INVITATION TO TENDER "ITT" PS20201112
CONTRACTOR FOR ANDERSON STREET UTILITY UPGRADE

ADDENDUM NO. 6

RE: REPLACE DRAWINGS

PROJECT
CITY OF VANCOUVER
ANDERSON STREET UTILITY UPGRADES

TITLE
SANITARY FORCEMAIN
PLAN, PROFILE AND DETAILS
STA. 0+000 TO 0+100

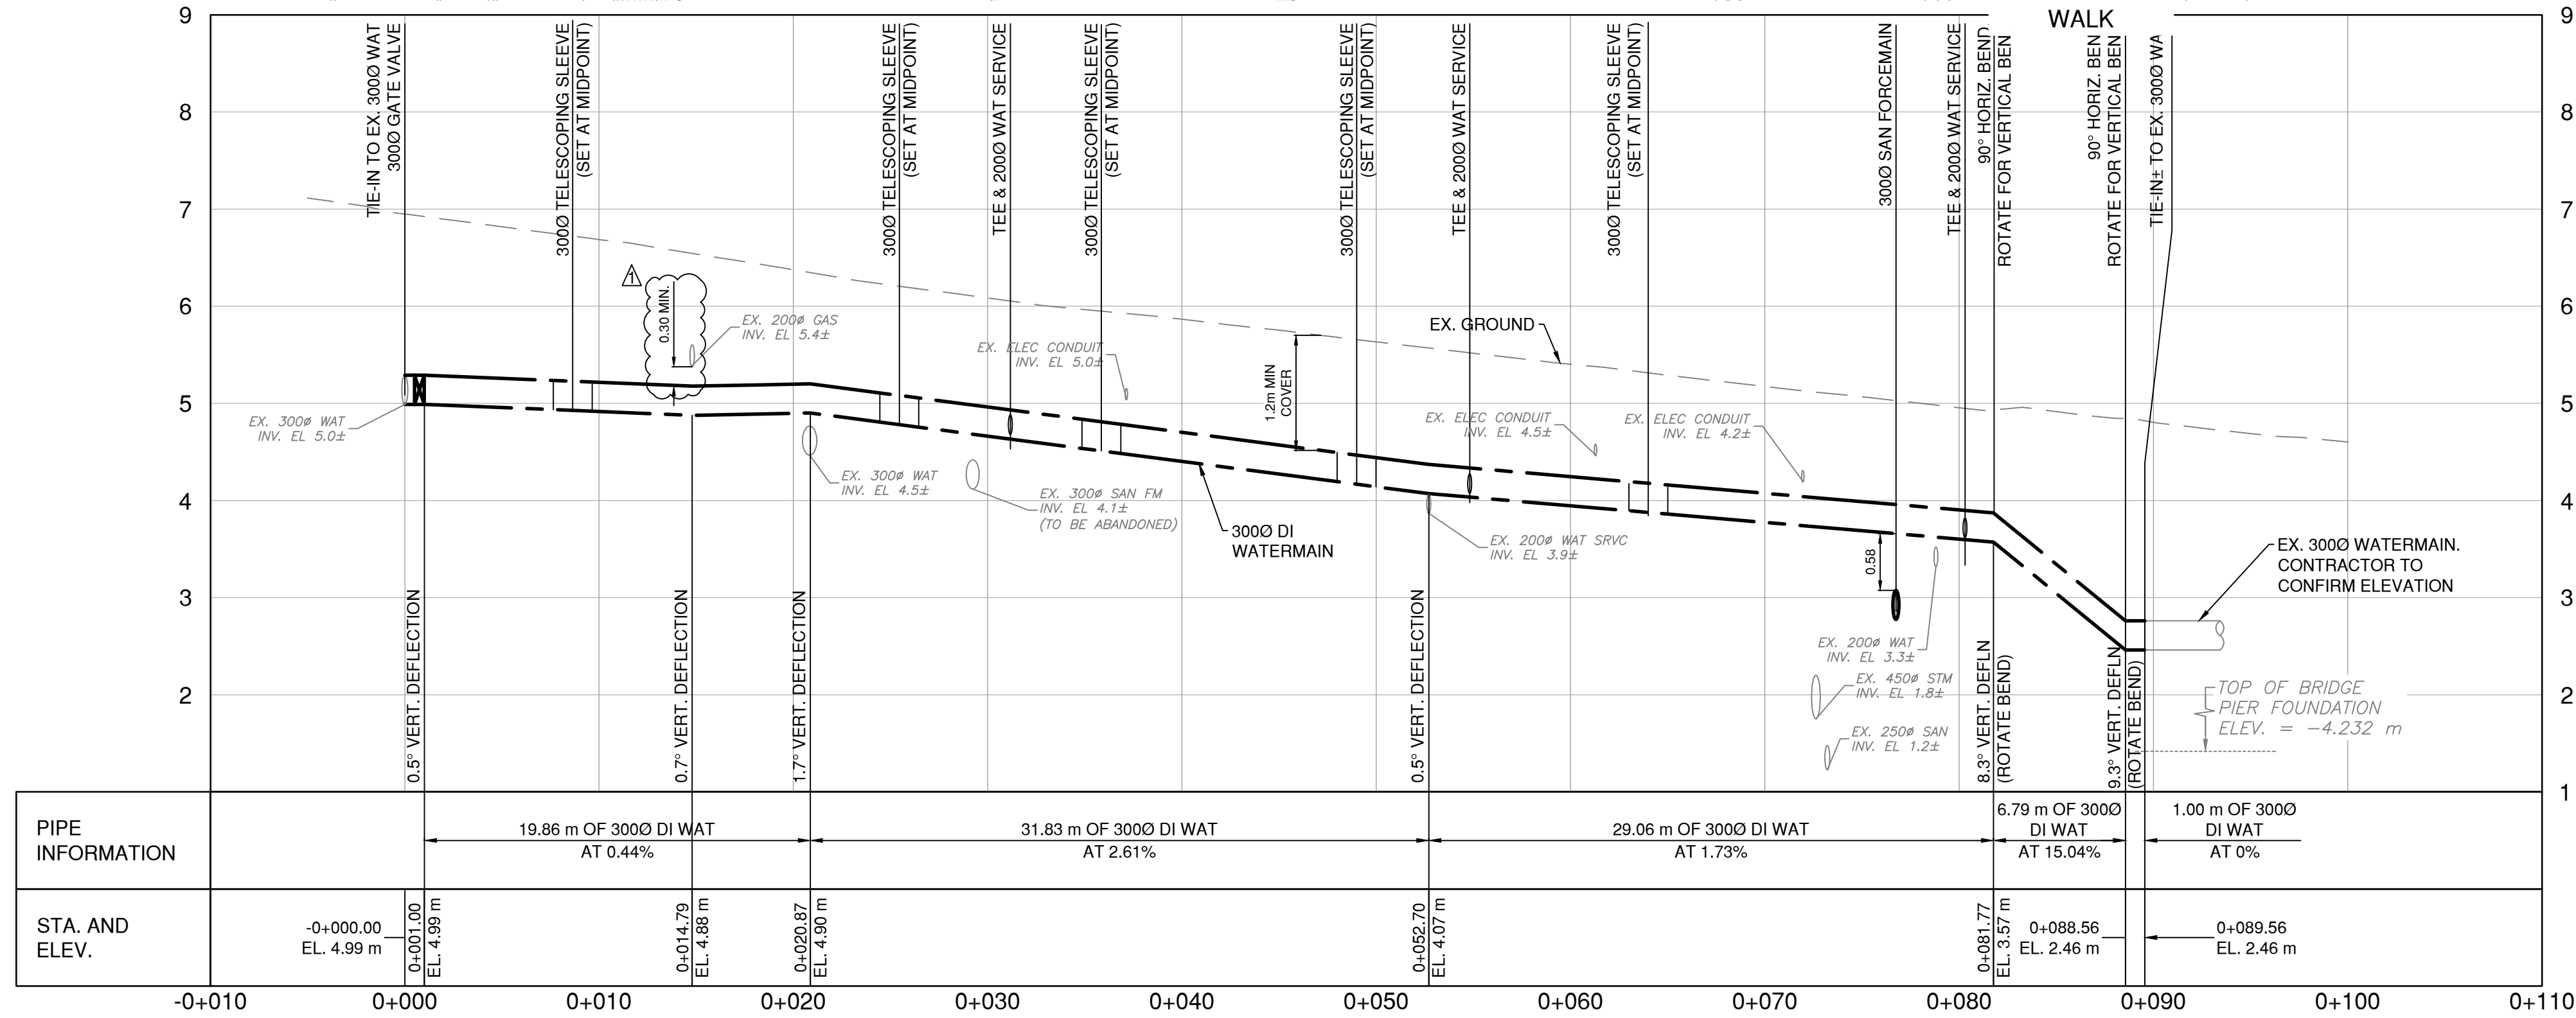
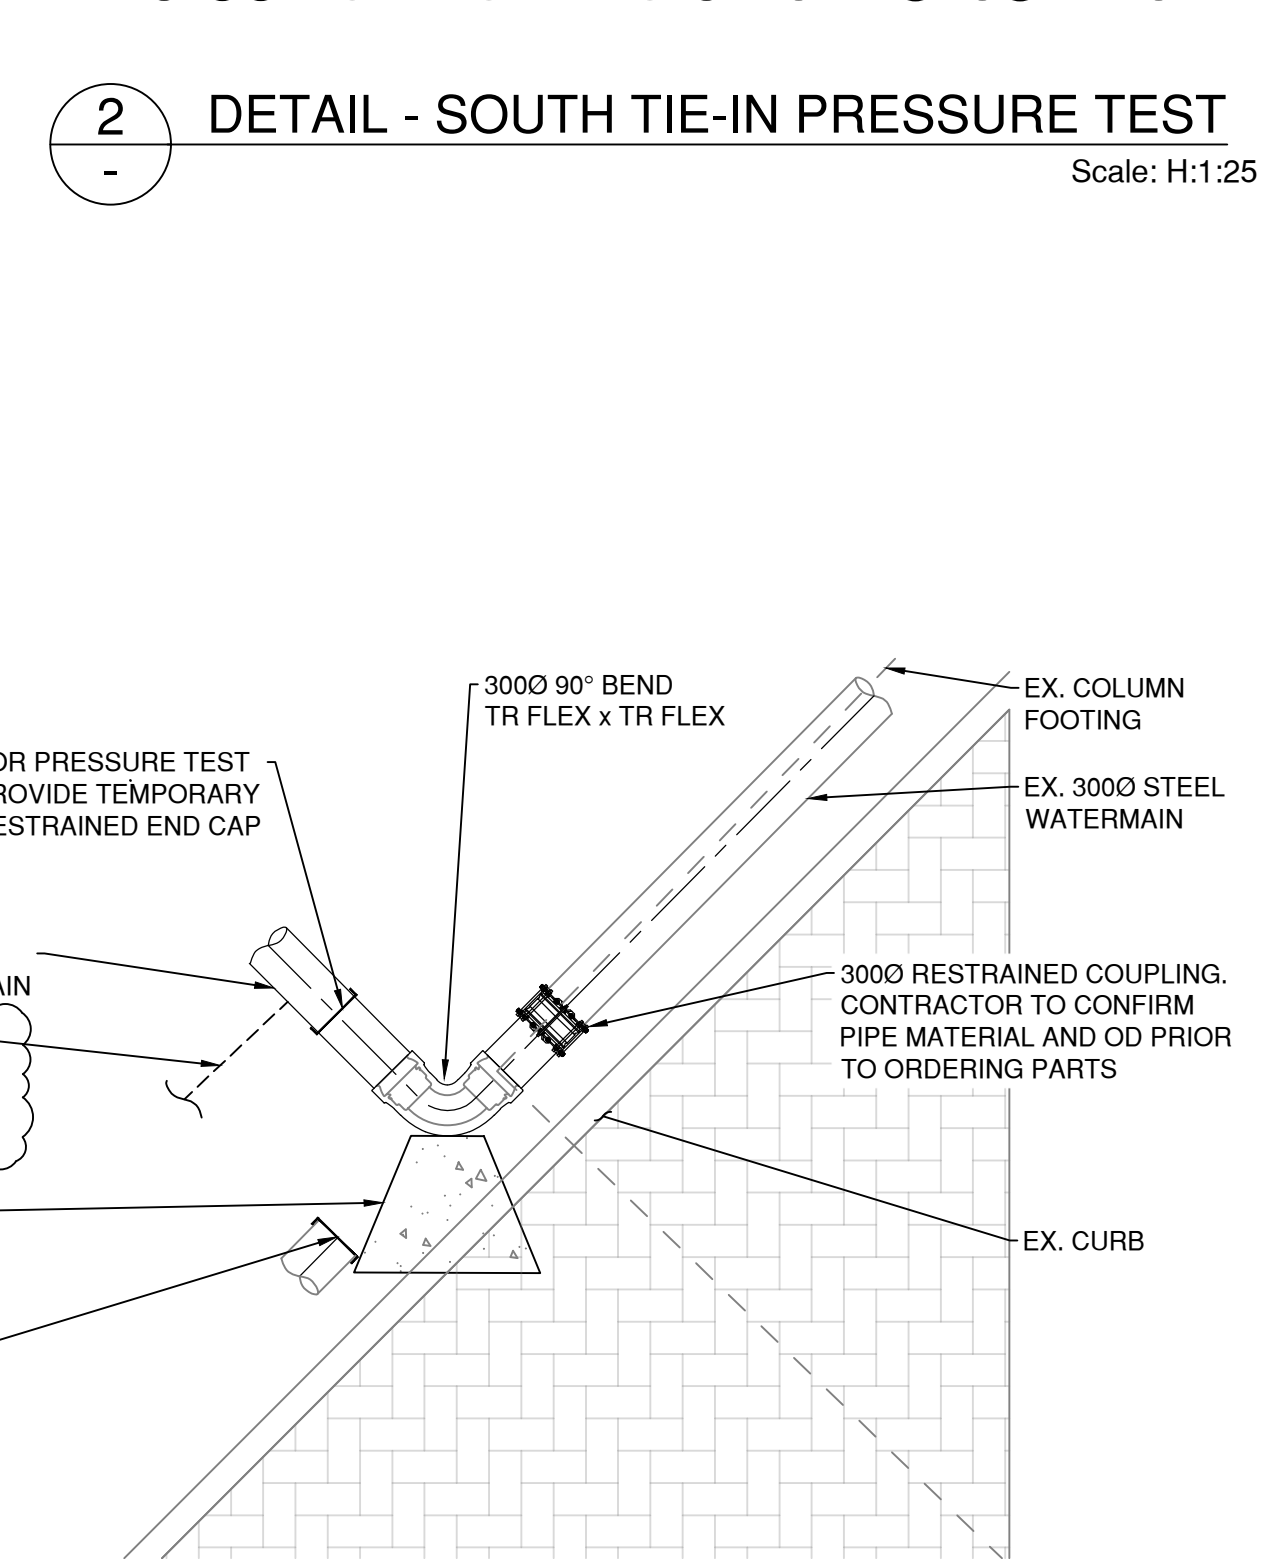
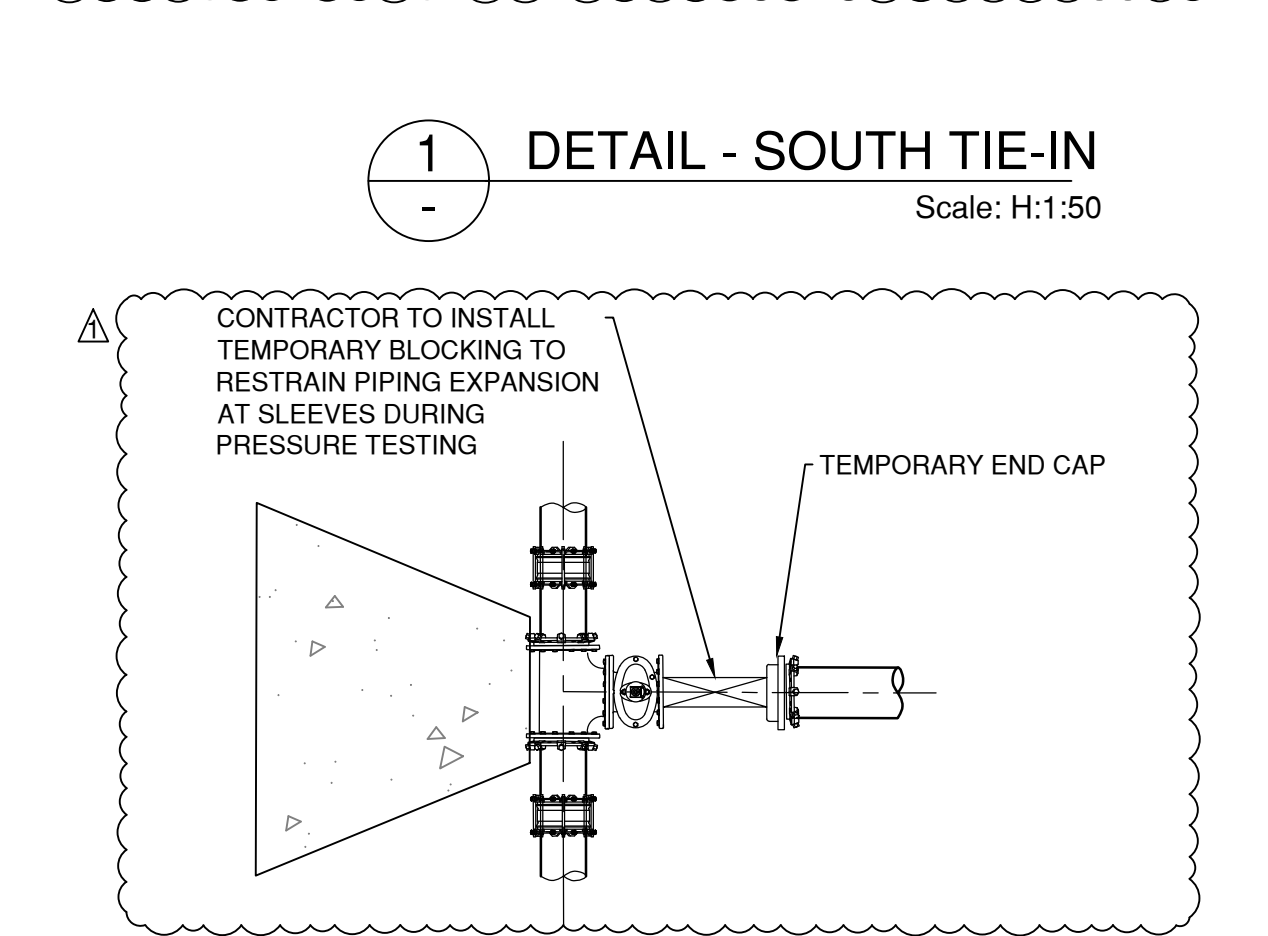
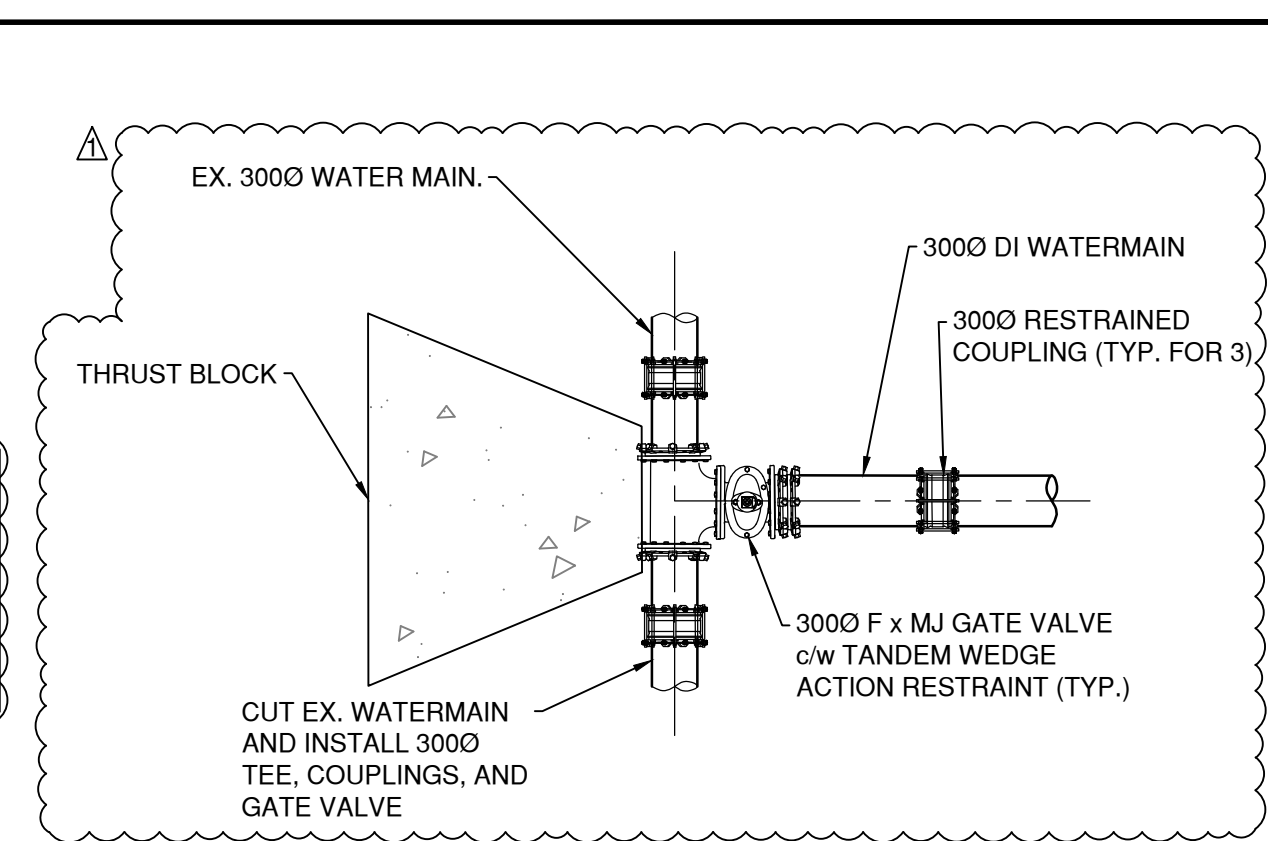
REV	BY	DATE	DESCRIPTION	DES	CHK
0	SP	14 OCT 2020	ISSUED FOR TENDER	SF	AB
1	SF	06 NOV 2020	GENERAL REVISIONS	SF	-
